**RE: Lot 25 Block 9 Unit 22, S.A.D. 228  
Volcano Cliffs Subdivision  
6511 Picardia Dr. NW  
Grading and Drainage Plan  
Engineers Stamp Date: 3/9/2022  
Certificate of Occupancy Date: 5/19/2023 (D10D003I25)**

Based upon the information provided in your submittal received 6/27/2023, this plan is approved for Certificate of Occupancy by Hydrology

CANDELARIA HOMES - STROMEI - G & D PLAN

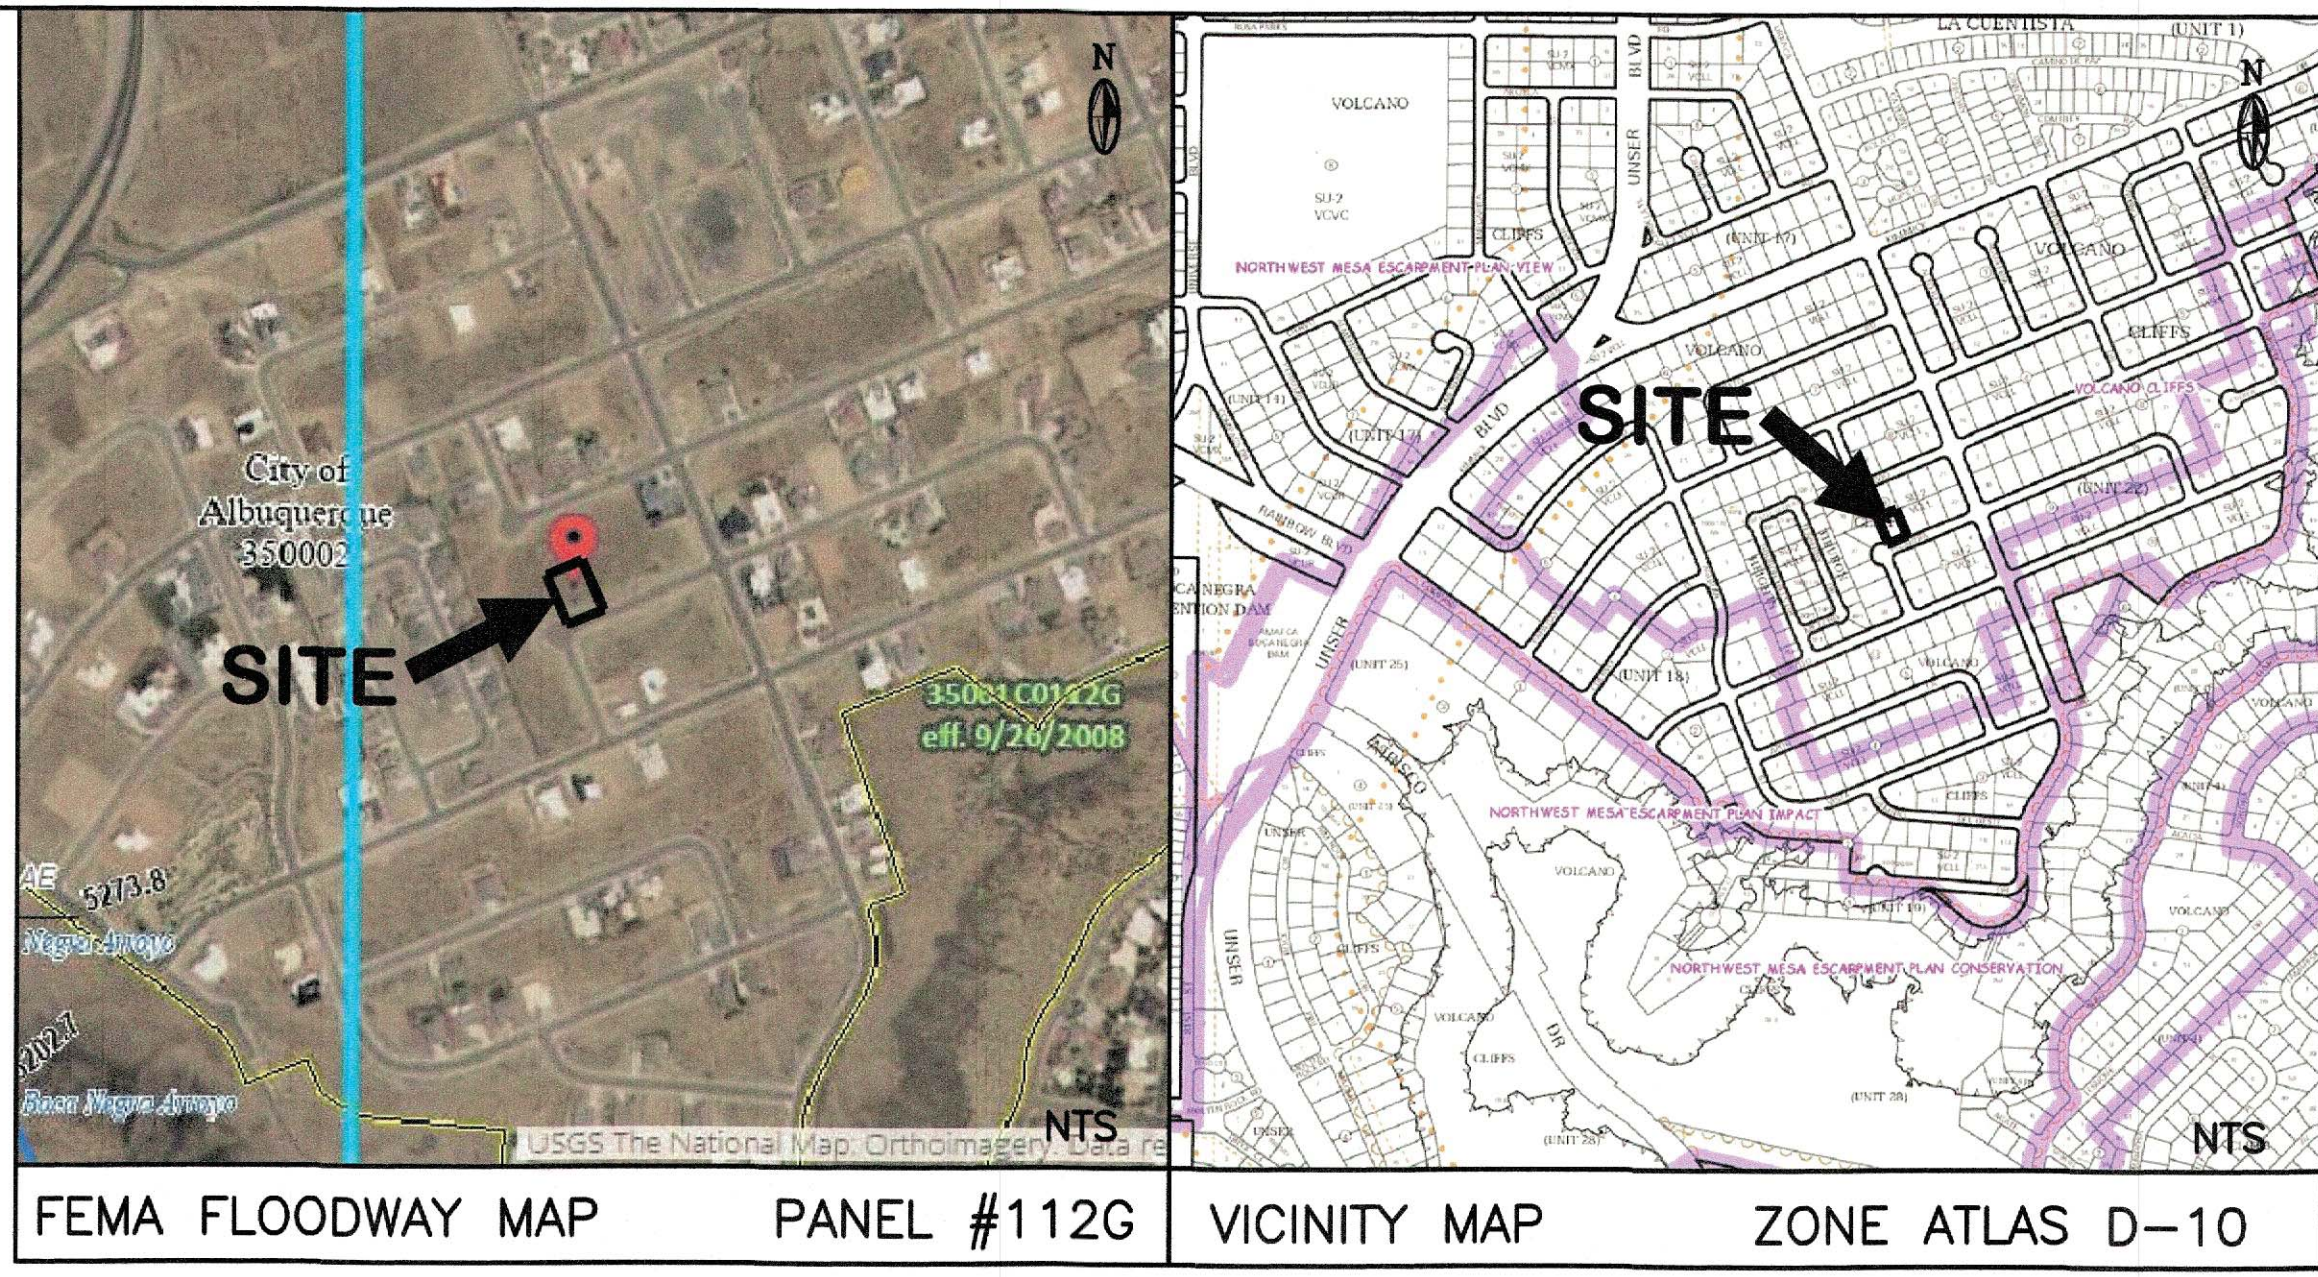
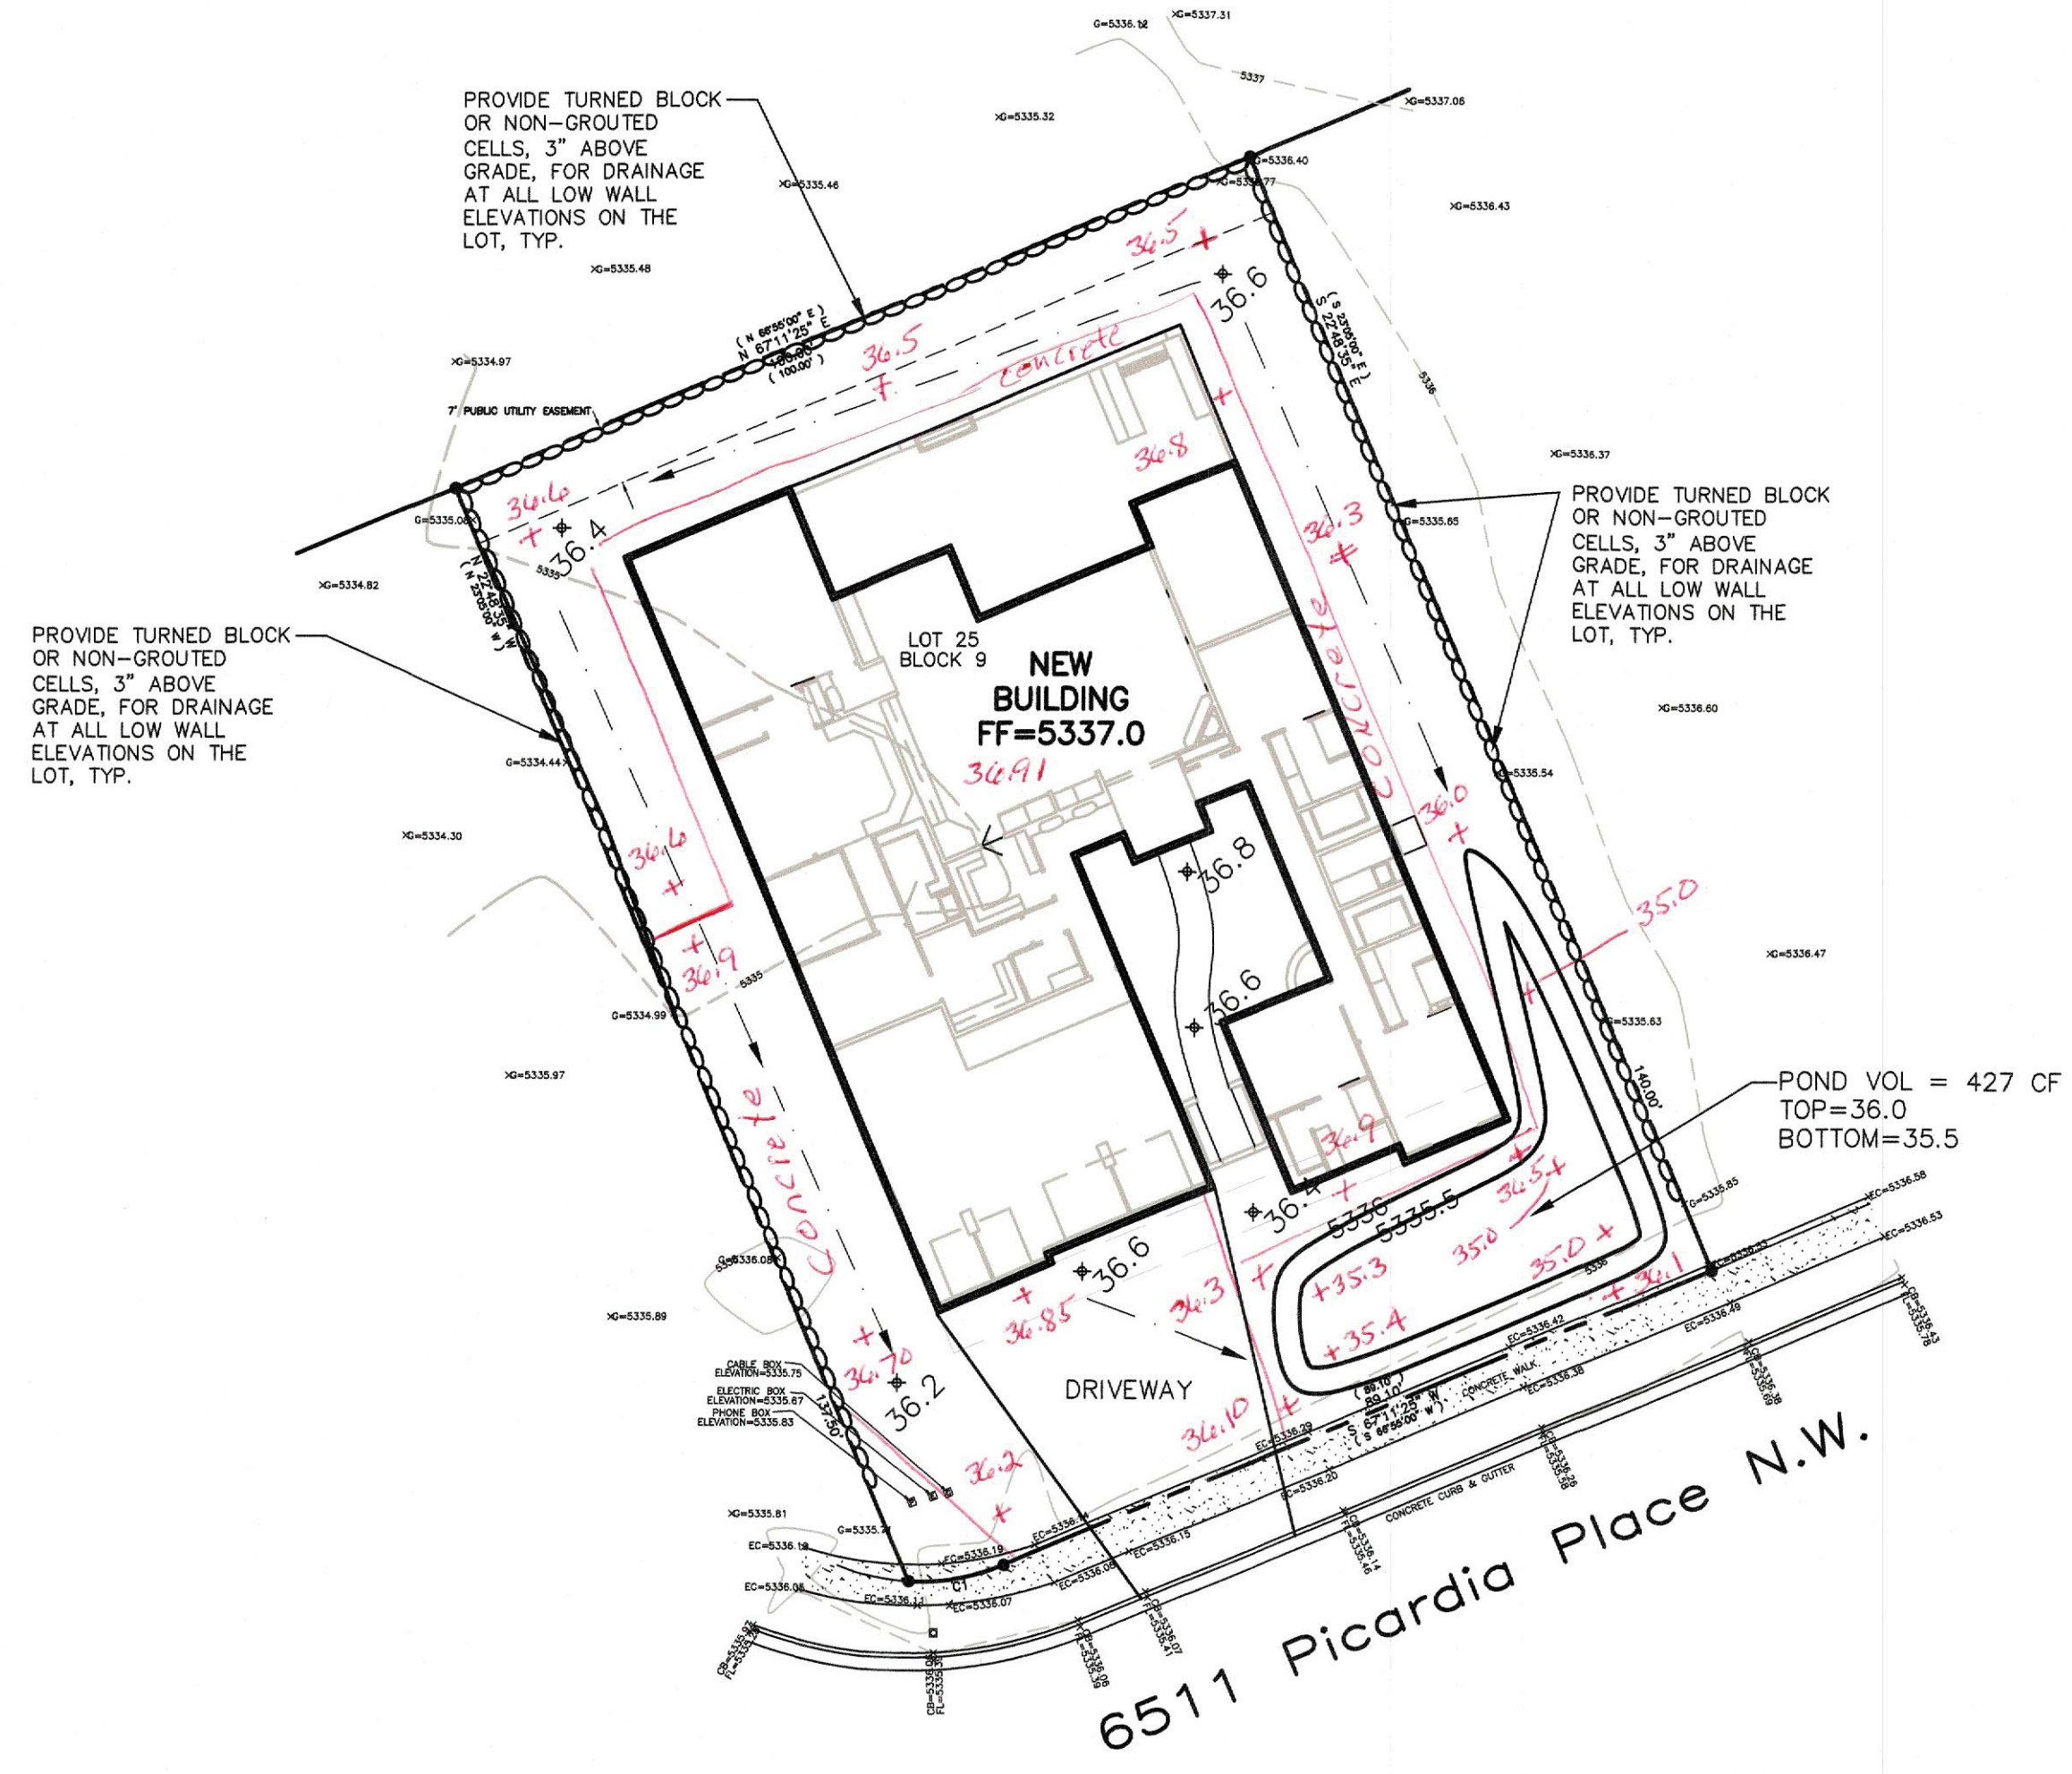
This is the plan to be used for any garden walls and any openings in the walls shall be placed 3" above final grade in the rear yard to allow for cross lot drainage from west to east (upstream to downstream).
